CITY OF ALBUQUERQUE

**RE: Lot 6-A Block 12 Unit 5 Volcano Cliffs SAD 227
6520 Jade Dr NW
Grading and Drainage Plan
Engineers Stamp Date 8/17/17 (D10D032)**

| CITY OF ALBUQUERQUE MUNICIPAL DEVELOPMENT DEPARTMENT ENGINEERING DIVISION 1620 JADE DRIVE NW GRADING & DRAINAGE PLAN | | | | | |

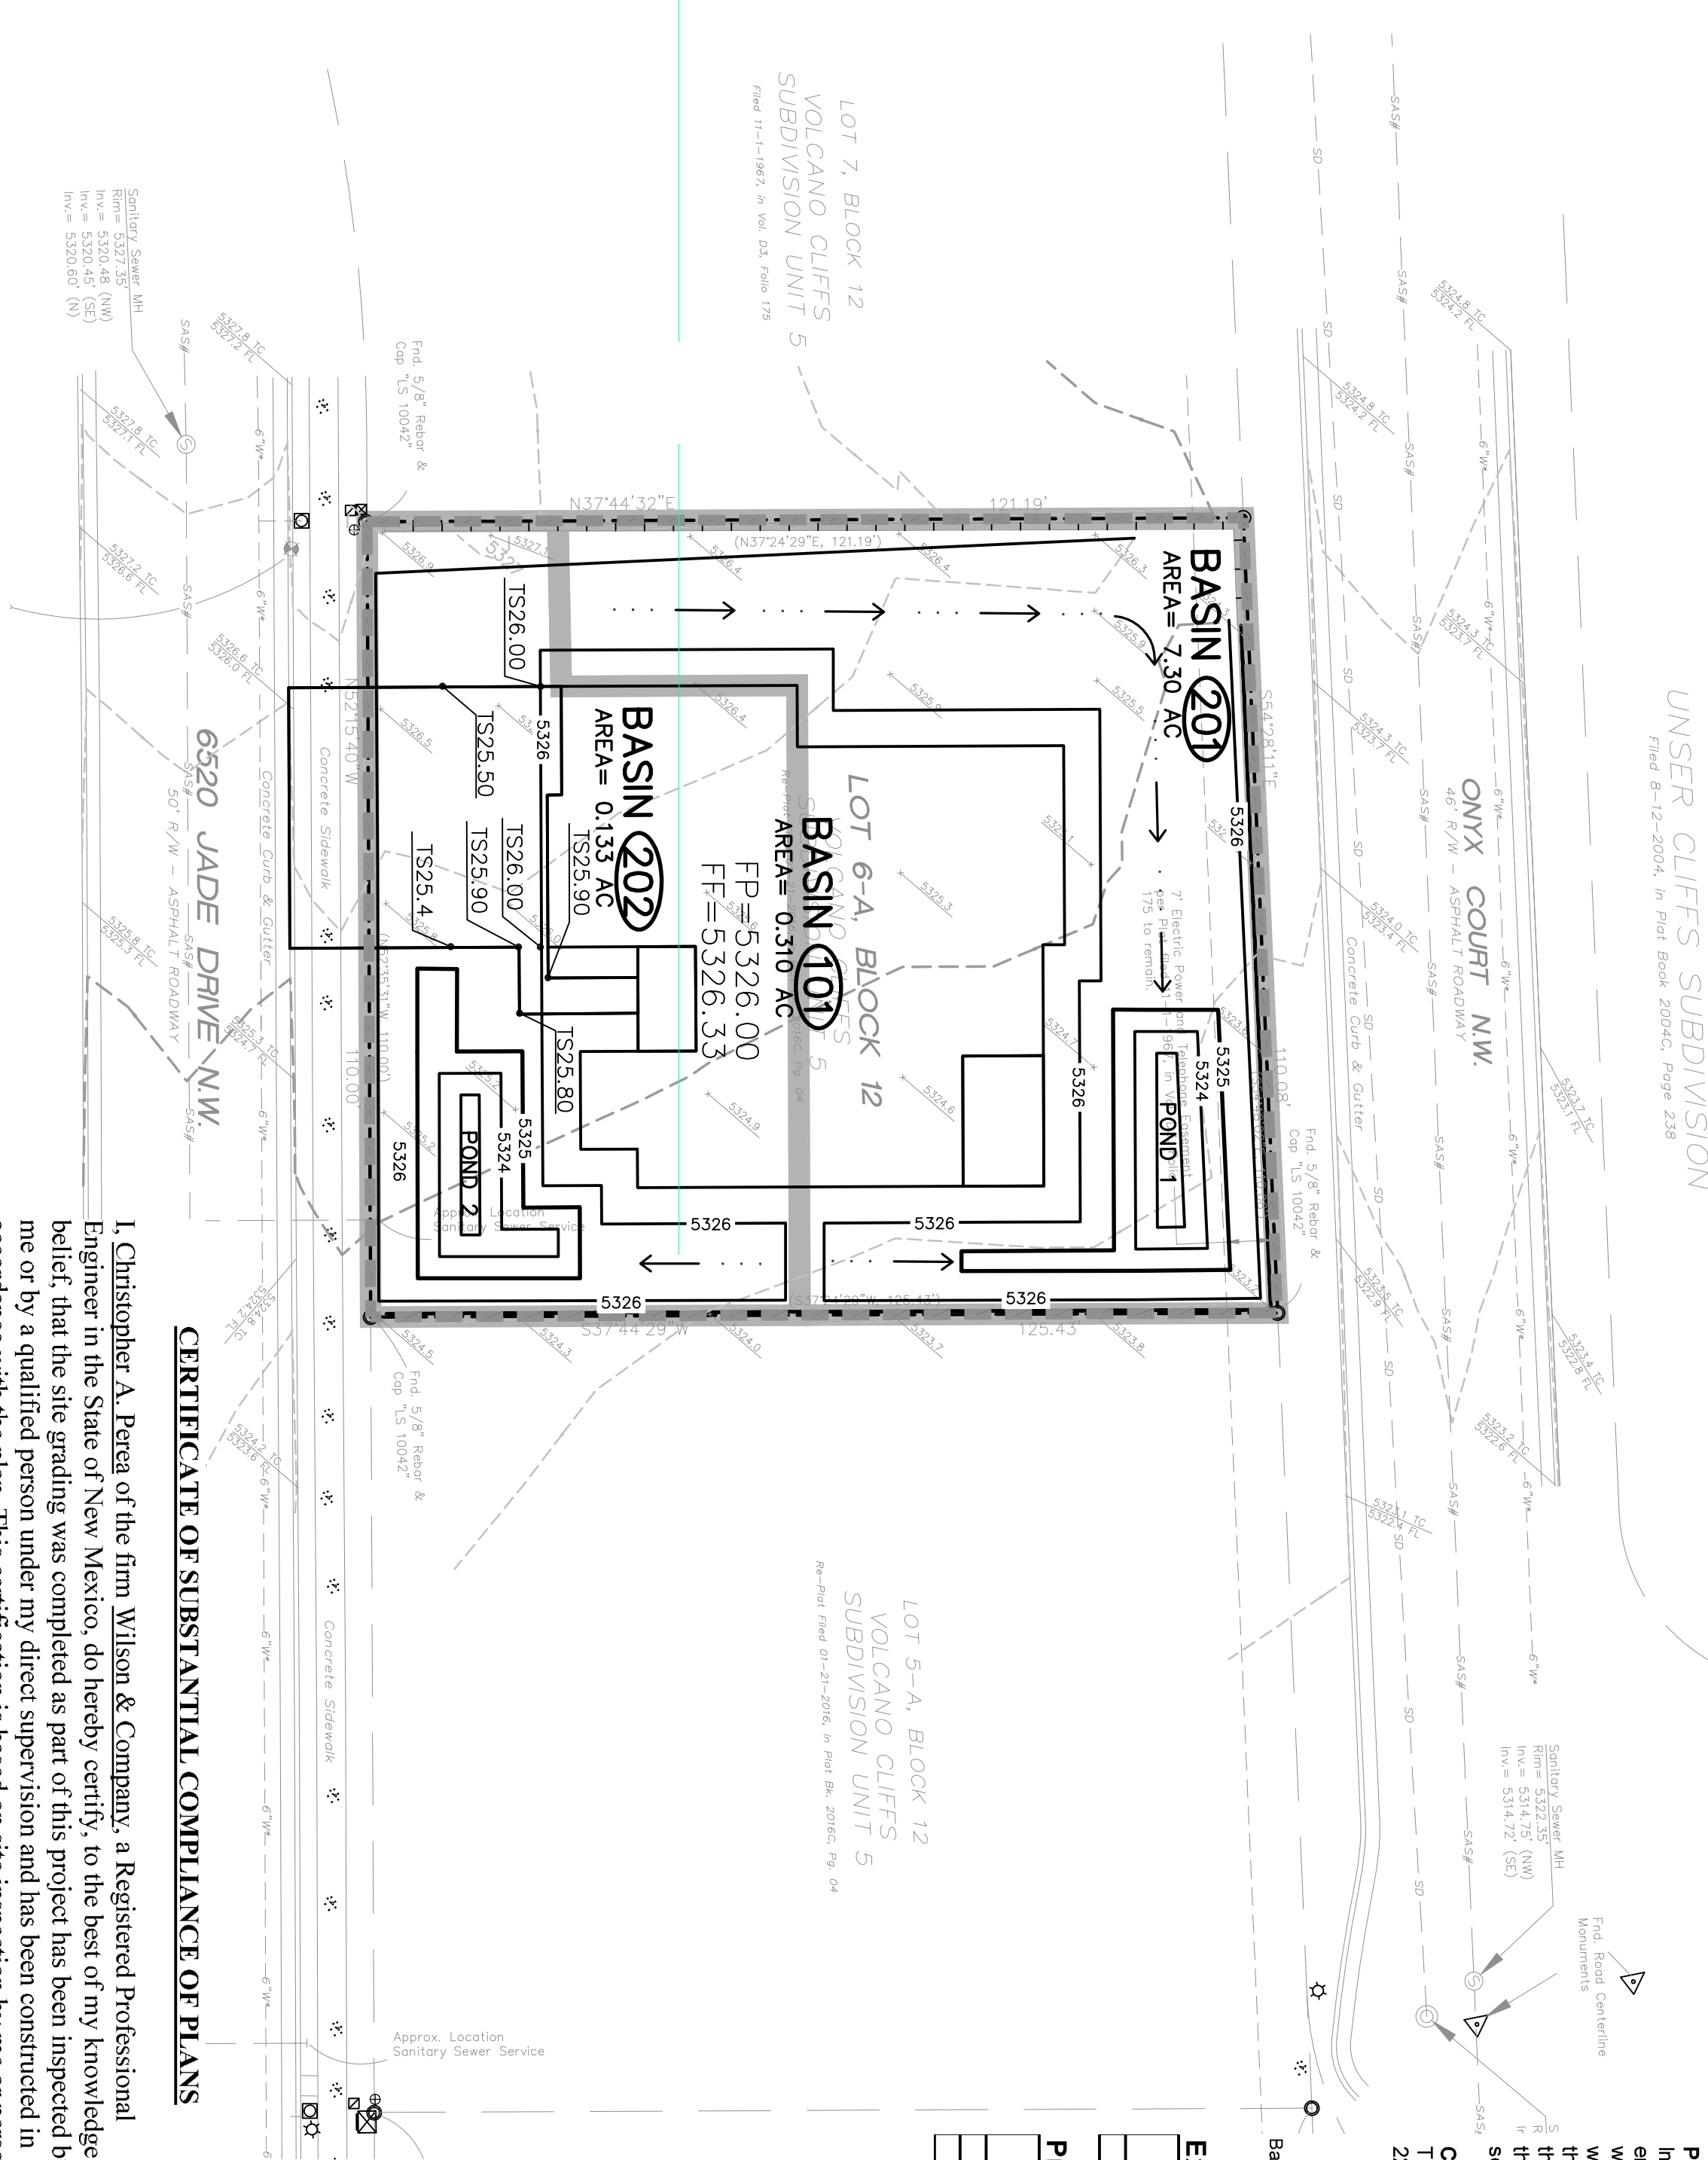
Based upon the information provided in your submittal received 8/30/17, this plan cannot be approved for Grading Permit until the following comments are addressed.

- Provide elevations in and around the site.
- Provide street elevations.
- A pad was not visible at the time of my field inspection.

If you wish to leave the note of pad certification along with your signature this will be fine. However, I still need elevation points in and around the site to make sure the home will not get flooded.
